# UNITED STATES PATENT AND TRADEMARK OFFICE

APPLICATION NO.	FILING DATE	FIRST NAMED INVENTOR	ATTORNEY DOCKET NO.	CONFIRMATION NO.
10/532,212	04/22/2005	Yasuhisa Yamada	. XA-10323	6753
181 MILES & STO	181 7590 02/07/2007 MILES & STOCKBRIDGE PC			
1751 PINNAC		•	COKER, ROBERT A	
SUITE 500 MCLEAN, VA 22102-3833			ART UNIT	PAPER NUMBER
MCEETTA, VI	. 22102 3033		3616	
SHORTENED STATUTO	RY PERIOD OF RESPONSE	MAIL DATE	DELIVERY MODE	
3 MONTHS		02/07/2007	PAPER

#### **DETAILED ACTION**

Figure A

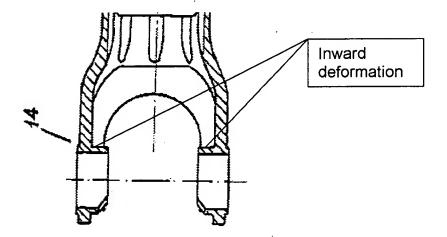
With respect to claims 10 and 13, Castellon discloses a telescopic shaft for a vehicle steering, wherein said female shaft comprises at an end thereof an inward

deformation portion, which is deformed inward (See Figure A above, the lower part of female shaft).
